Shiprock Pinnacle Hotel & Restaurant

Highway 491 & Turquoise LN, Shiprock, NM 87420
Dyron Murphy Architects Project No. 2022.10

ADDENDUM No. 3

December 15, 2023

A6 LOW ROOF FRAMING PLAN - RESTAURANT
 SCALE: 3/16" = 1'-0"

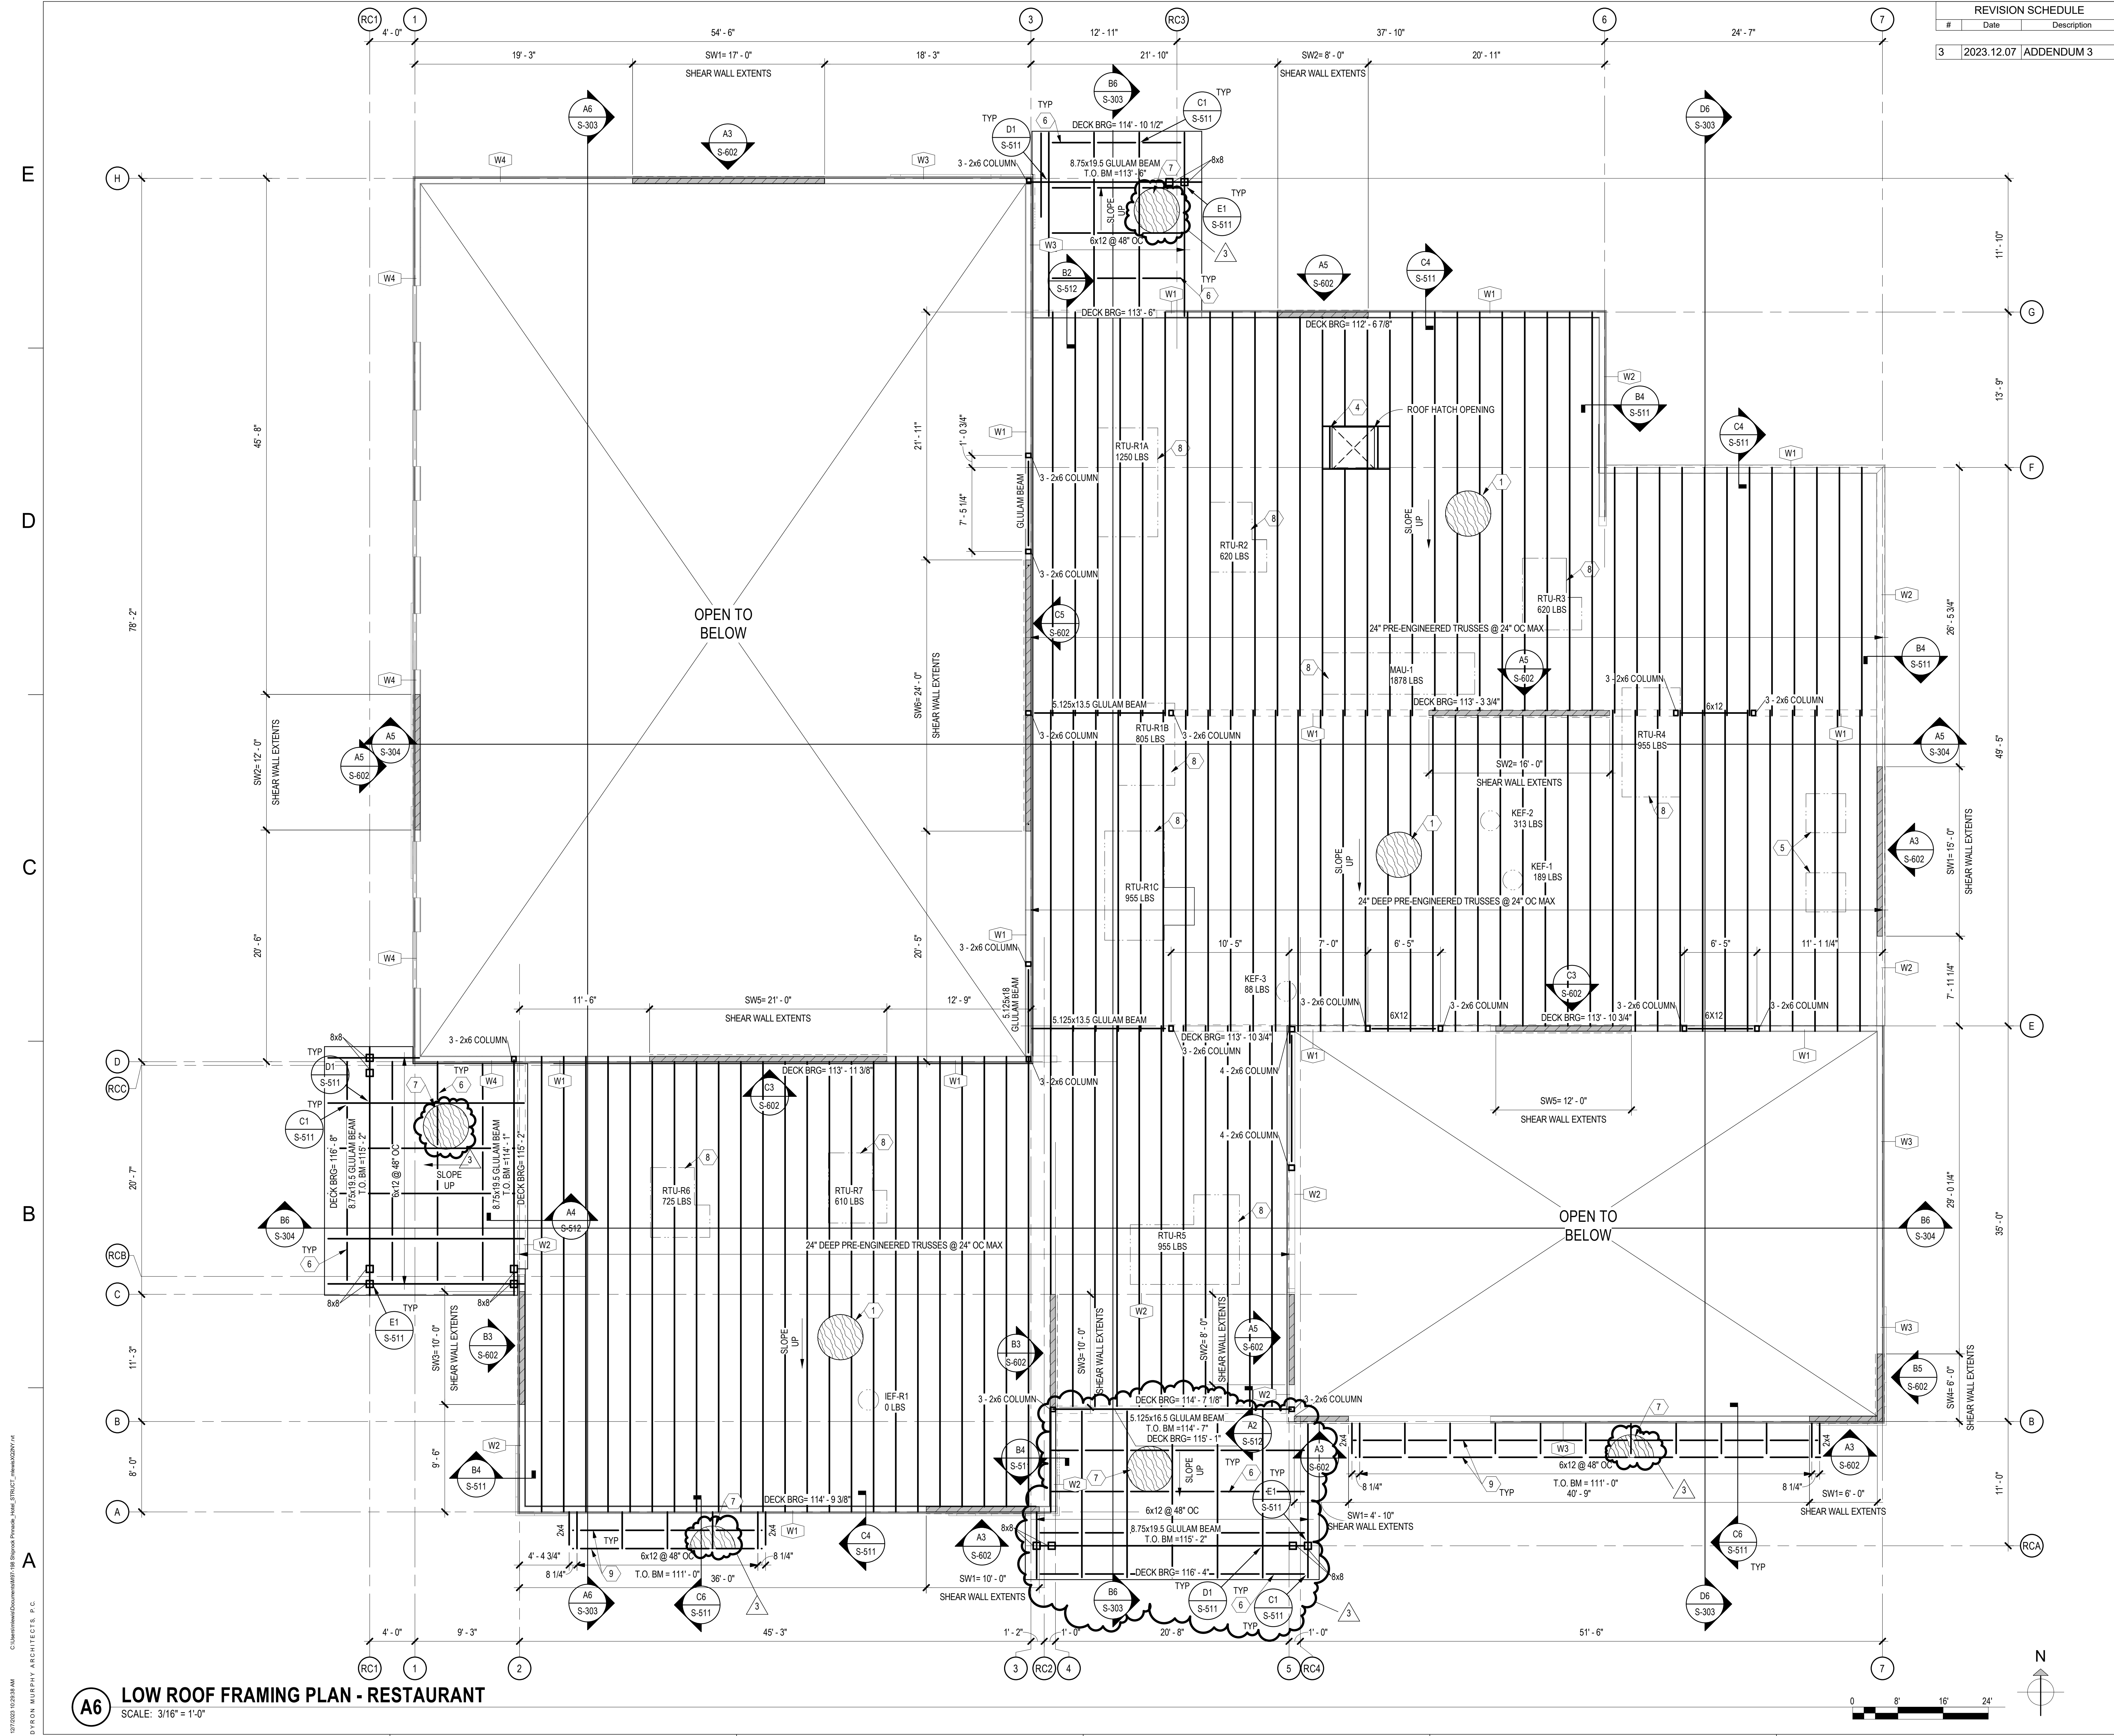
S-122 - LOW ROOF FRAMING PLAN - RESTAURANT

- Revised spacing of beams at south entry canopy.
- Updated pattern of sheet note '7' roof deck symbol.

C3 EAST ELEVATION
1/8" = 1'-0"

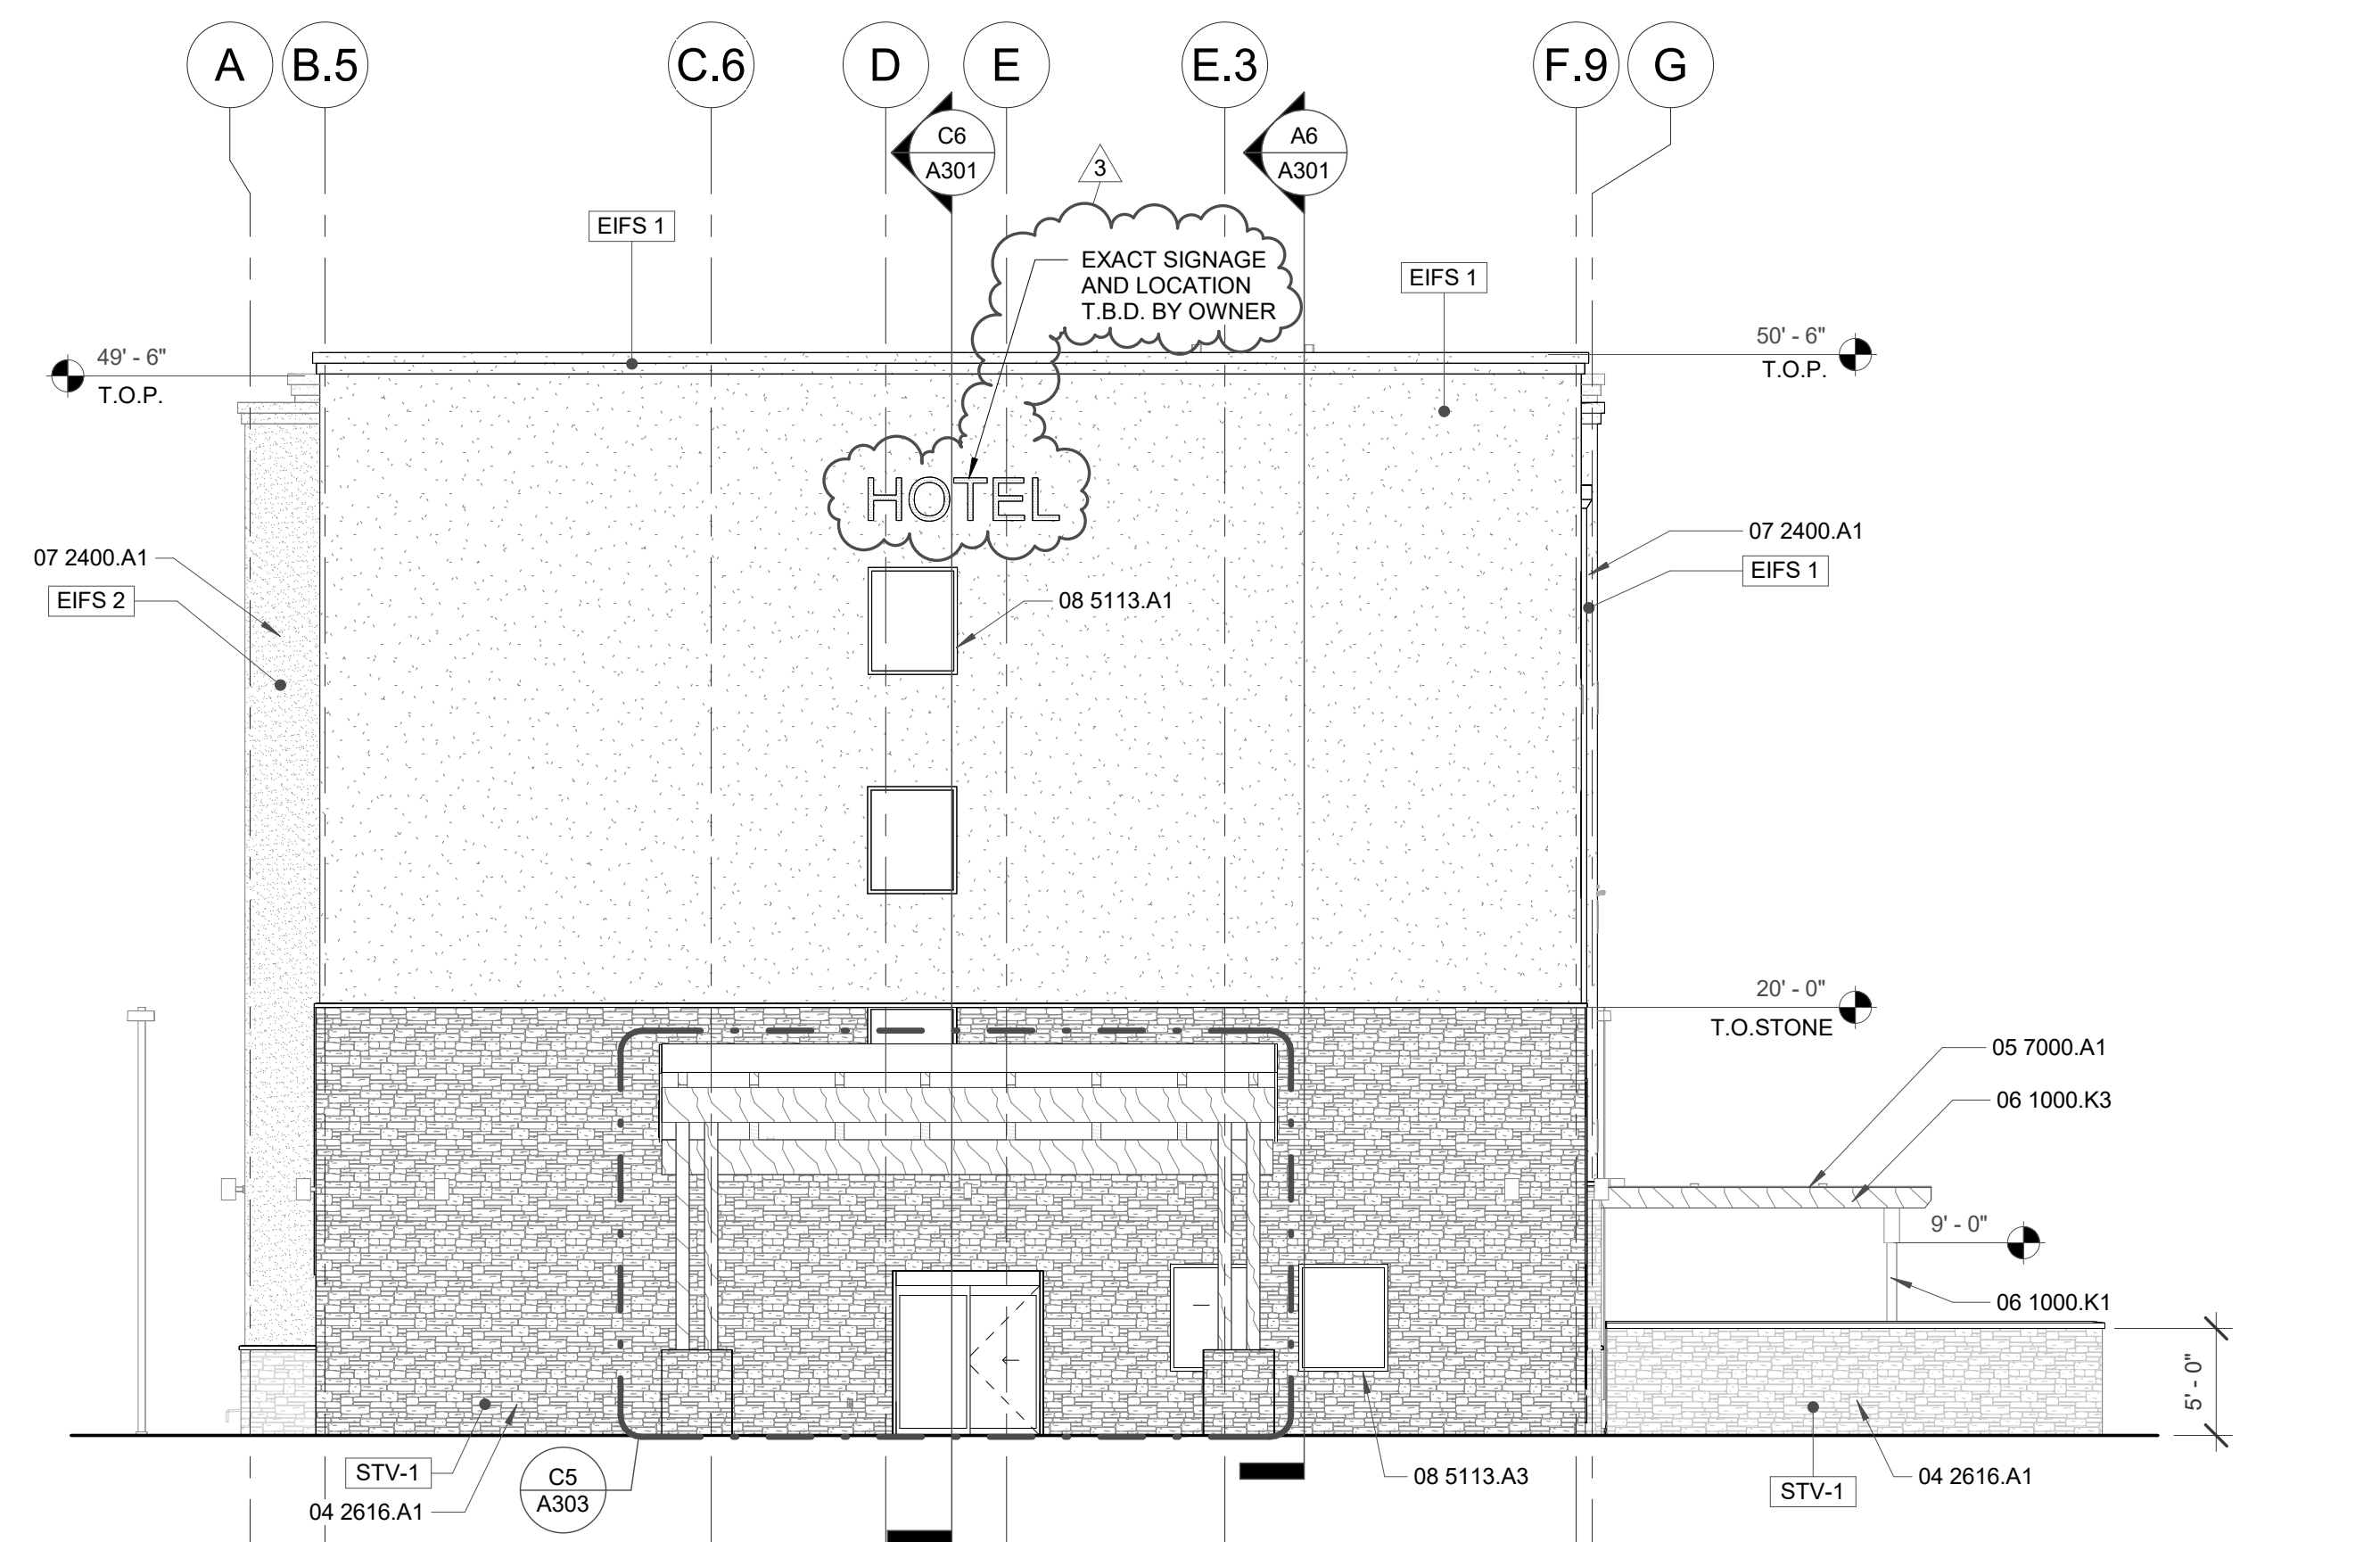
7. *Sheet A202 Exterior Elevations – Hotel. Detail A6 South Elevation. Please confirm if “HOTEL” signage design intent is to be illuminated. If so, is the intent to be back-lit or face lit?*

A201 – EXTERIOR ELEVATIONS – HOTEL

- Added exterior signage to east wall.

The hotel exterior building signage shown on detail A6/A202 is to be back lit. A similar sign shall also be provided on east elevation detail C3/A201. See attached re-issued updated sheet A201.
